UNITED STATES PATENT AND TRADEMARK OFFICE

APPLICATION NO.	FILING DATE	FIRST NAMED INVENTOR	ATTORNEY DOCKET NO.	CONFIRMATION NO.
10/709,580	05/14/2004	Paul K. MEEKER	43064-0030	3579
24115	7590	06/26/2006	EXAMINER	
BUCKINGHAM, DOOLITTLE & BURROUGHS, LLP			EDELL, JOSEPH F	
50 S. MAIN STREET			ART UNIT	
AKRON, OH 44308			PAPER NUMBER	
			3636

Office Action Summary	Application No.	Applicant(s)	
	10/709,580	MEEKER ET AL.	
	Examiner	Art Unit	
	Joseph F. Edell	3636

DETAILED ACTION

Diagram A - Annotated Figure 8 of Burleigh et al.

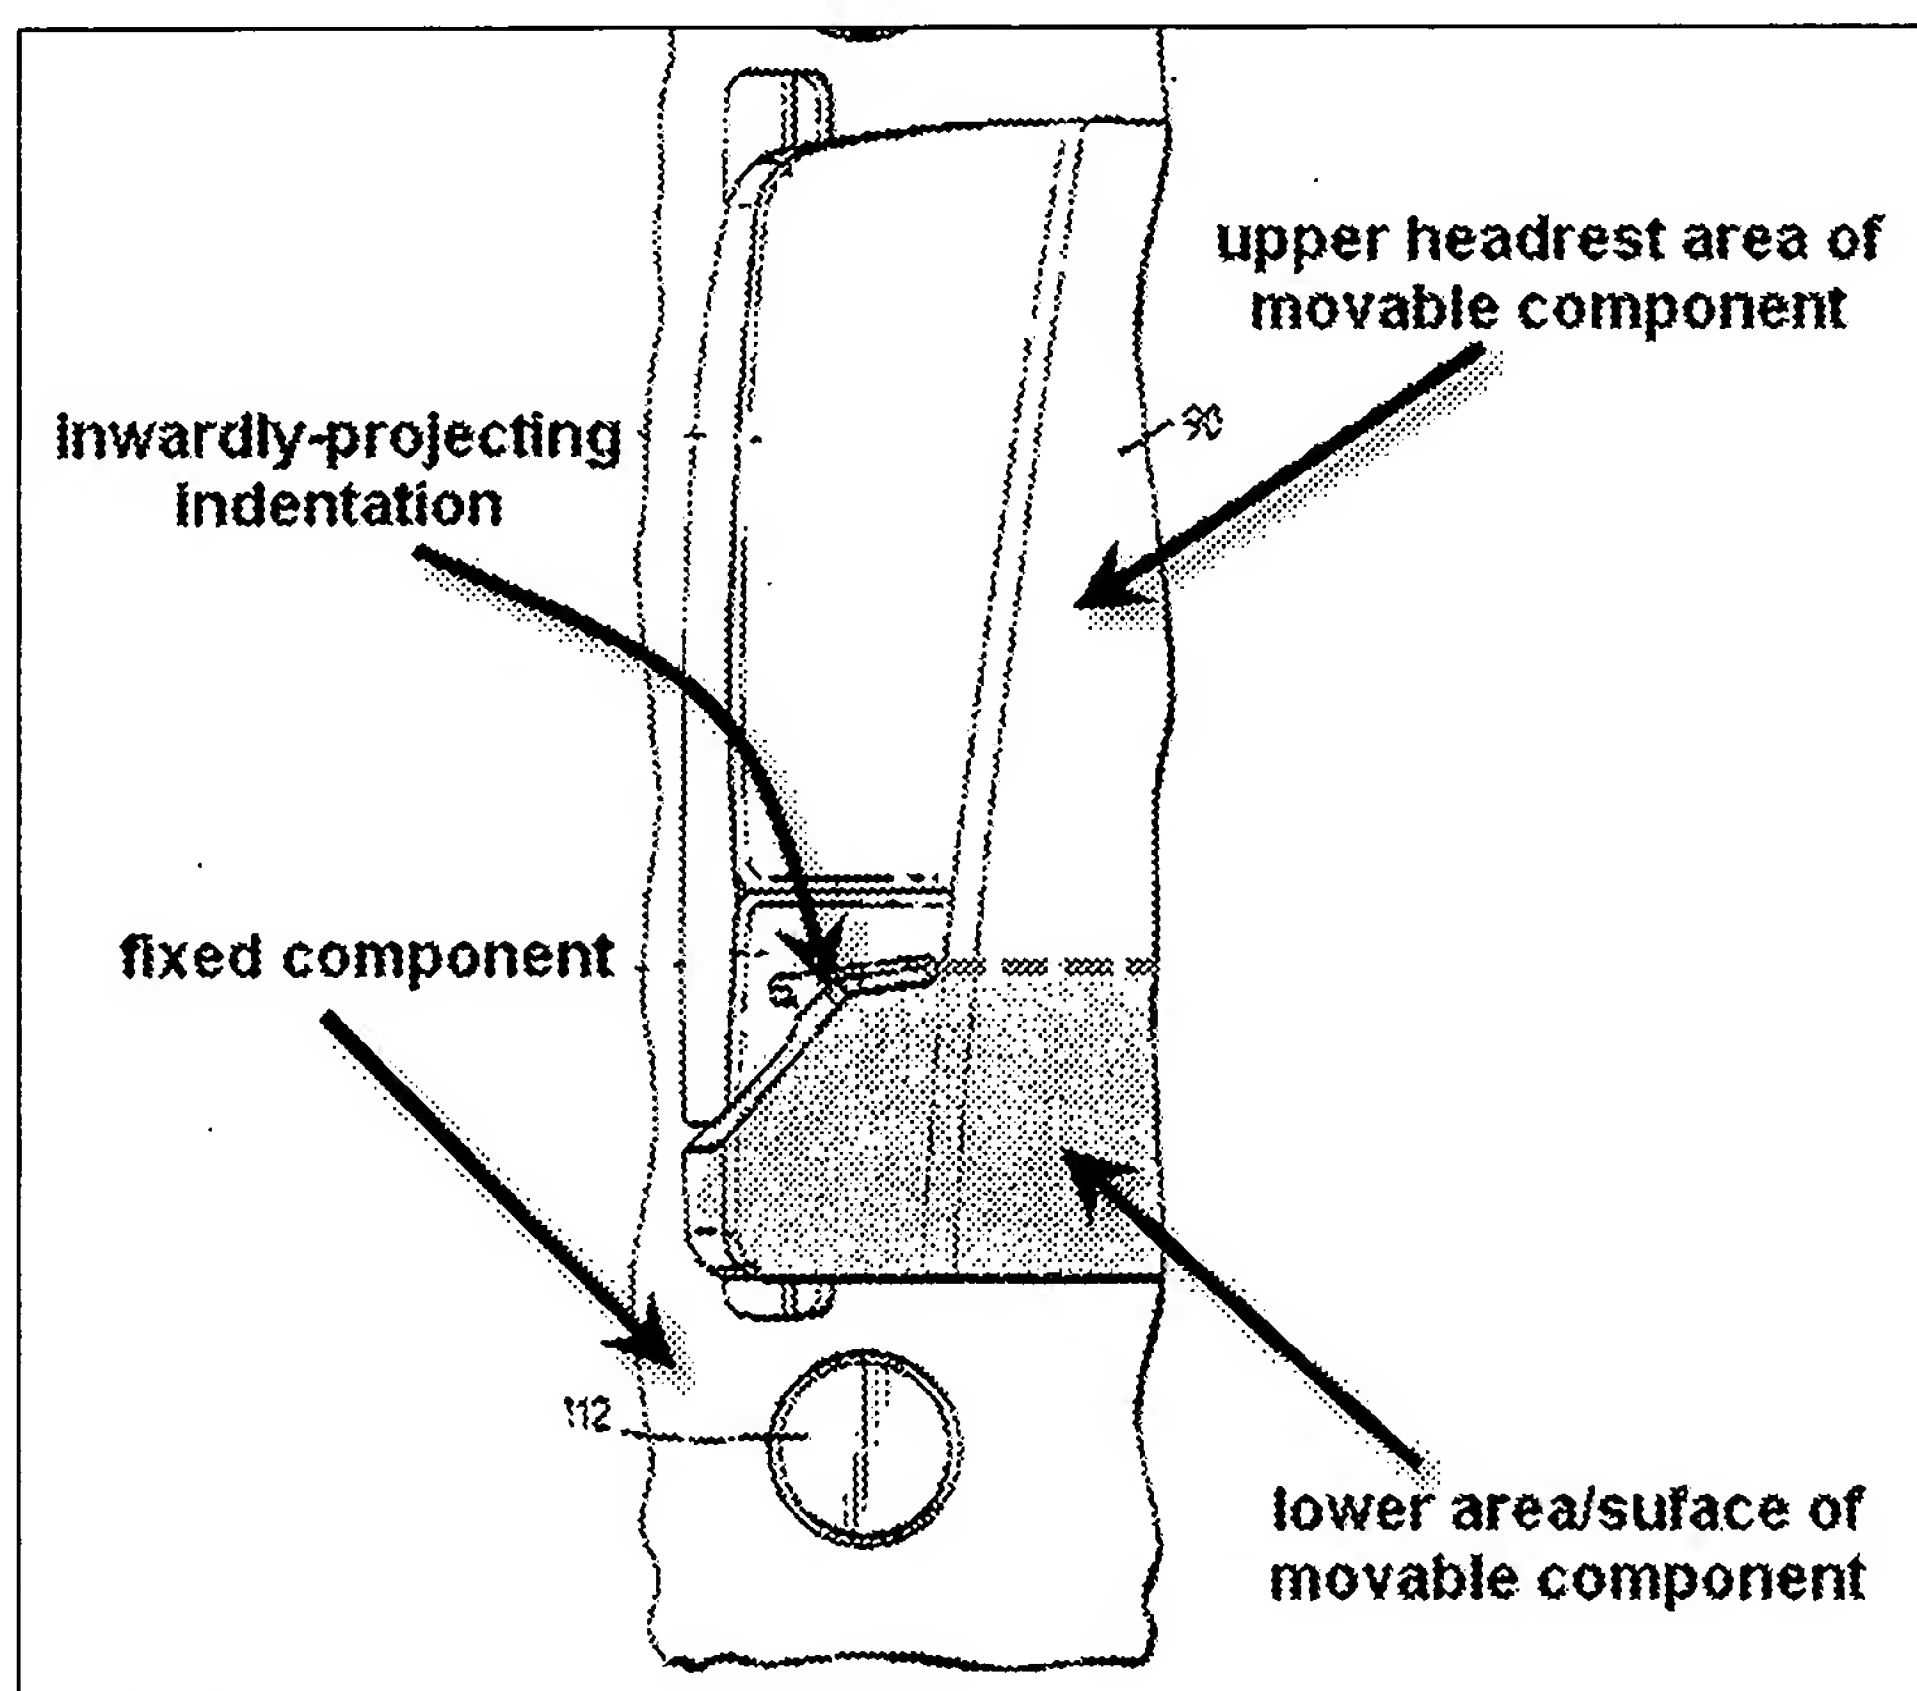
Burleigh et al. disclose a car seat that includes all the limitations recited in claims 1-8, 10-20, 22-30, and 32. Burleigh et al. show a seat having a seat member 72 (see Fig. 5), a back member 78 connected to the seat member, a fixed component (see Diagram A below) of the back member including raised contoured sides 80,82 (see Fig. 6) and contoured surface in cross-section, a movable component 90 of the back member including raised contoured sides 92,94, capable of movement from a retracted position to an extended position, and overlapping the fixed component, an upper headrest area of the movable component (see Diagram A) with a pair of forward extending wings, and an opposed lower area (see Diagram A) separated from the upper headrest area by a pair of fixed size inwardly-projecting indentations 126,128 (see Fig. 8 and Diagram A) to accommodate a shoulder belt, fixedly connected to the upper headrest area, and including a surface and a contour in cross-section mating the contoured surface of the fixed component.

Burleigh et al. show a back member wherein the upper headrest area being in invariant fixed relationship to the lower area and separated by the indentations (see Diagram A), the movable component is attached in front of the fixed component, the fixed and movable components being in overlapping essentially gapless relationship with respect to each other with sliding movement between the components at both the retracted and extended positions (sliding movement of shoe parts 118 along tracks 96,98 - see Fig. 6 - allowing for the gapless relationship), the sliding movement between

the components does not increase a size of the indentations between the upper headrest area and lower area, and means for selectively positioning and retaining the movable component relative to the fixed components (the shoe parts and tracks are functionally equivalent to the positioning and retaining structure described in the instant application) that permits incremental discrete movement or infinitely variable movement and is a pair of outwardly biased shafts 118 capable of locking, and telescoping movement of the movable component relative to the fixed component which is fixed by a length of longitudinal channels 96,98 in the fixed component.

With respect to claim 11 and 13-15, movement of the movable component 90 of Burleigh et al. relative to the fixed component 78 provides contiguous essentially parallel surface support for an occupant's back without increasing the size of the indentations, the inner contour of the movable component mates and nests with an outer contour of the fixed component, and an outer contour of the movable component has a pair of raised surfaces for side support of the occupant.
